Groundwater Application Review Summary Form

Application # G- ~~18643~~ ⁸¹ 18463

PUBLIC INTEREST REVIEW FOR GROUNDWATER APPLICATIONS

SUBJECT: Application G- 18463 Supersedes review of NA
Date of Review(s)

Figure 1. Water Availability Tables

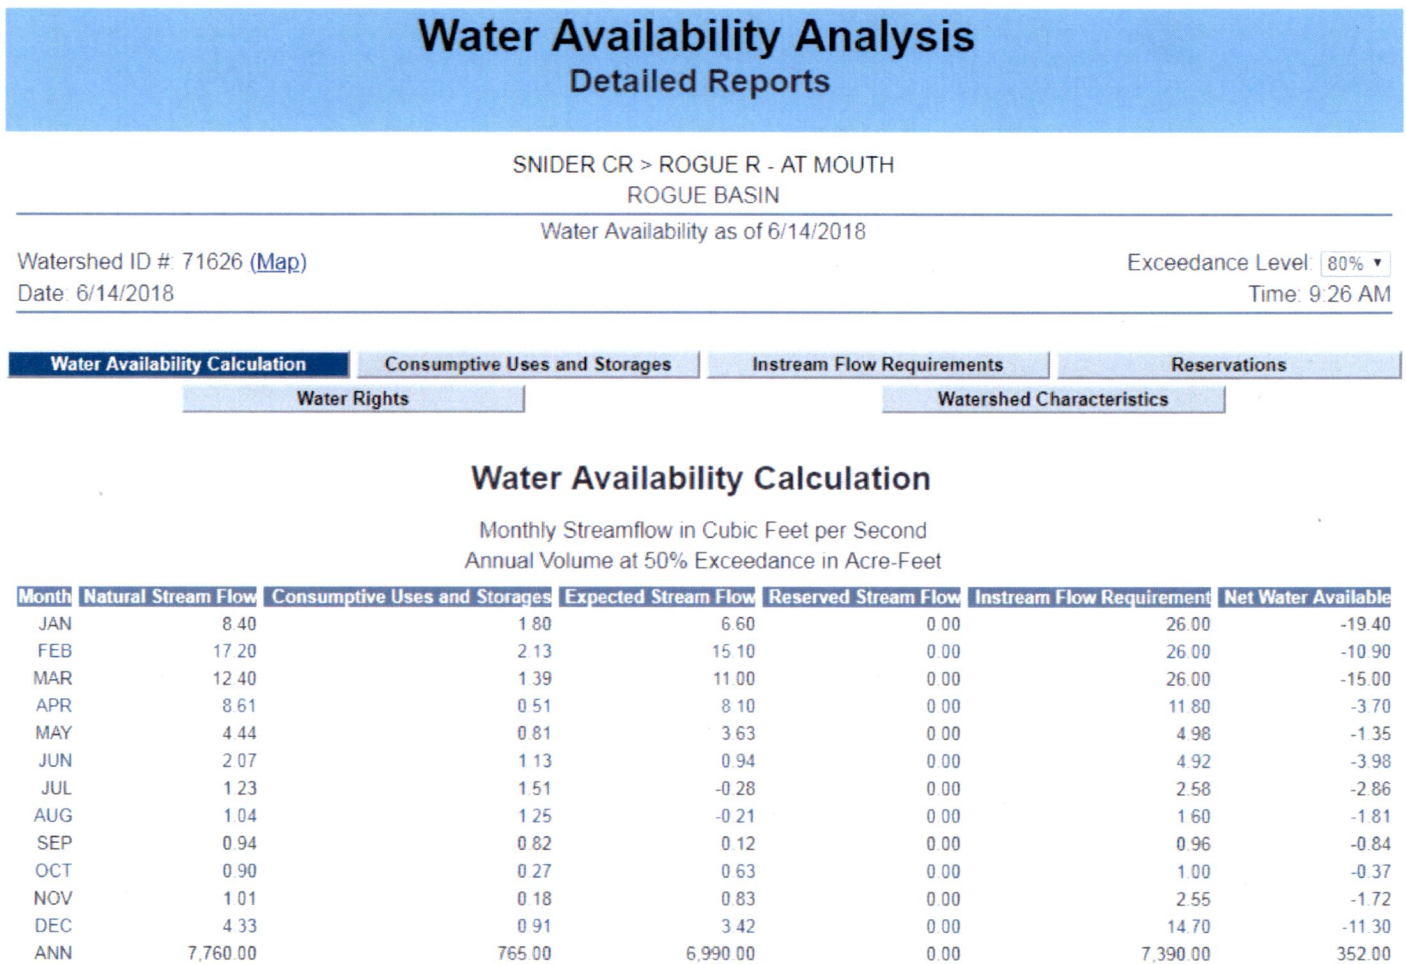
The proposed POAs are determined to be hydraulically connected within 1 mile of Snider Creek. The proposed rate of 0.058 cfs is larger than 1% of the instream water right on Snider Creek (1% of 0.96 cfs) and 1% of the expected natural flows on Snider Creek (1% of 0.90 cfs), thus triggering an assumption of PSI per OAR 690-0040(4). The applicant would need to reduce their total proposed rate to < 0.009 cfs or 4 gpm to avoid triggering an automatic assumption of PSI.

Figure 2. Well Location Map

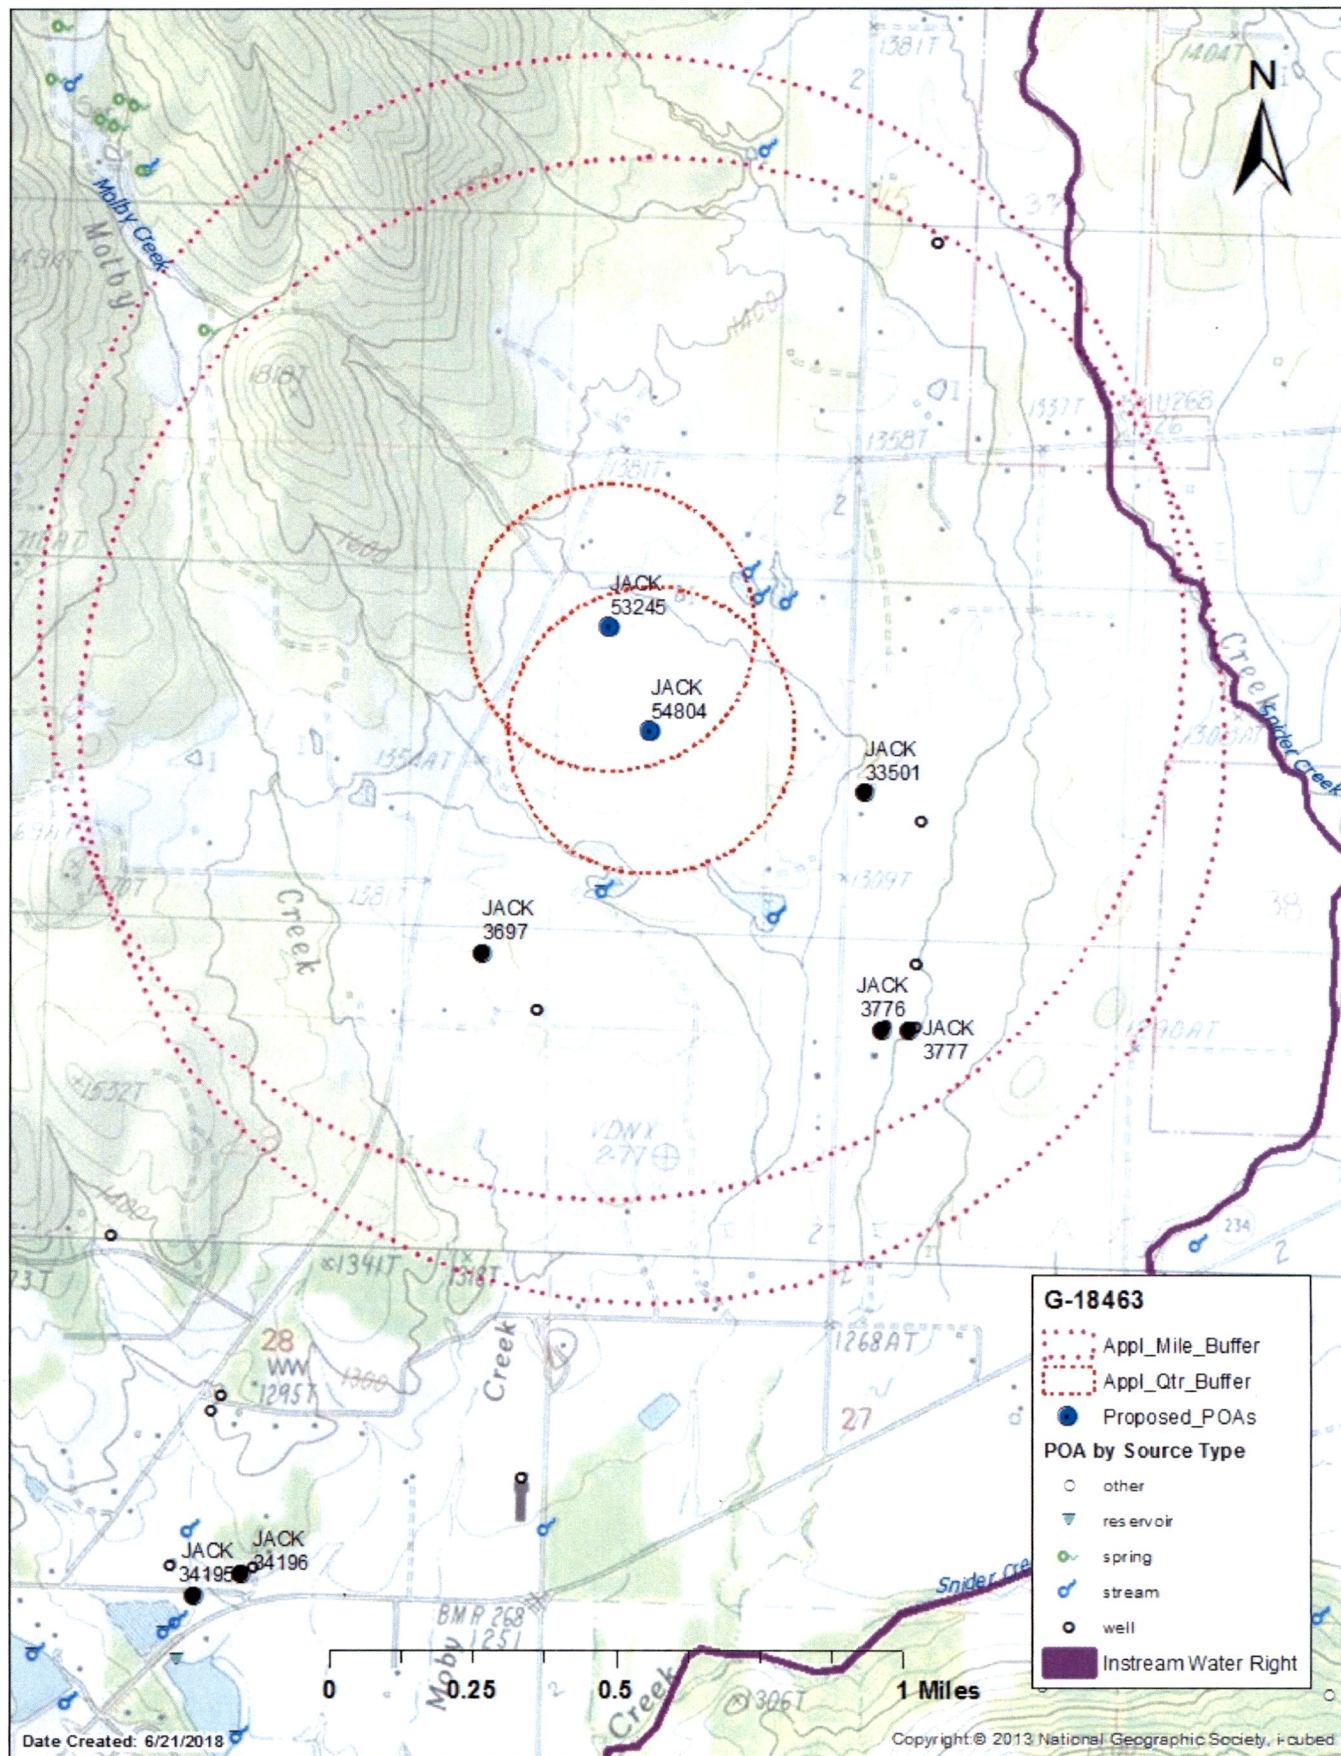
There are few permitted groundwater POAs adjacent to the proposed POAs, all at least ½ mile away. As such, there is not likely to be significant injury or interference to senior users.

Figure 3. Water-Level Trends in Nearby Wells

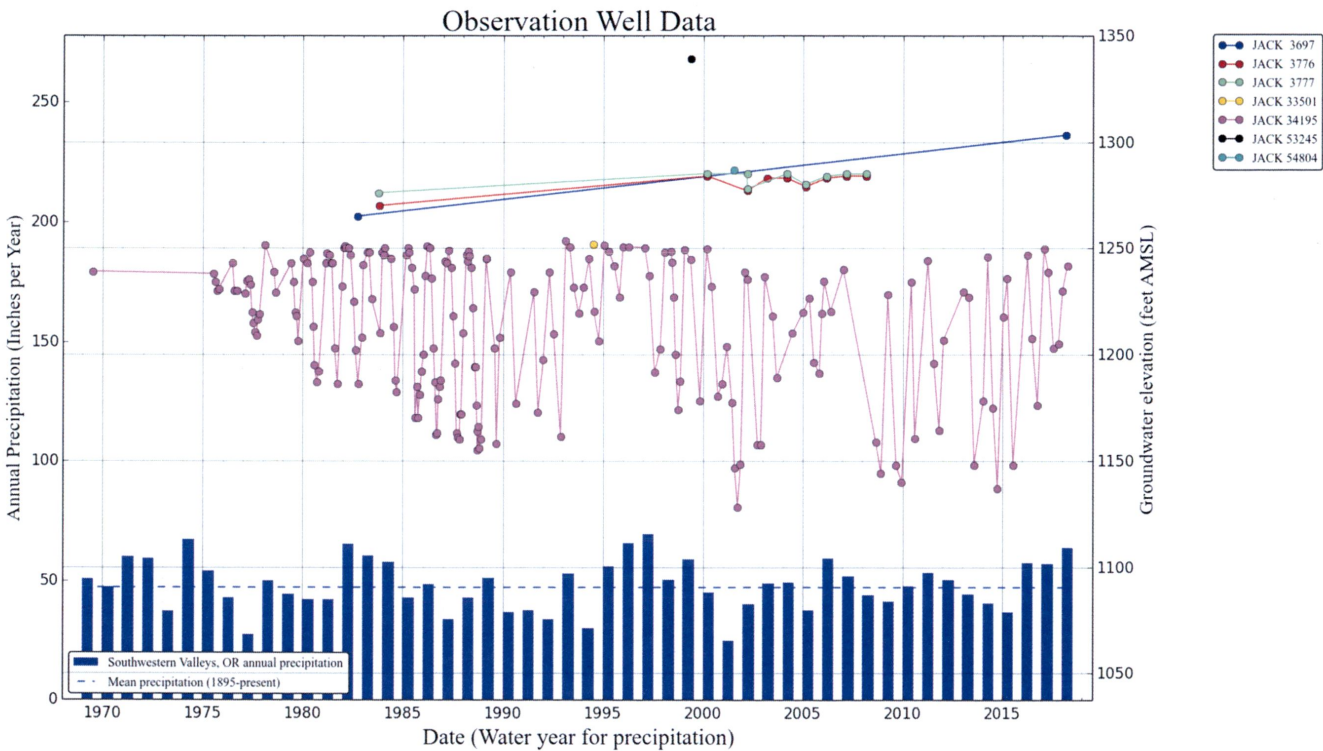
- B3. **Groundwater availability remarks:** SWLs observed at wells close to the proposed POAs (< 1 mile) show stable trends from 2000 – 2008 (see Figure 3). SWLs observed at SOW JACK 34195 (2 miles away) show stable trends from 1970 to present. It is reasonable to conclude from this combination of spatial and temporal data observed in this aquifer system that the resource is not over appropriated.
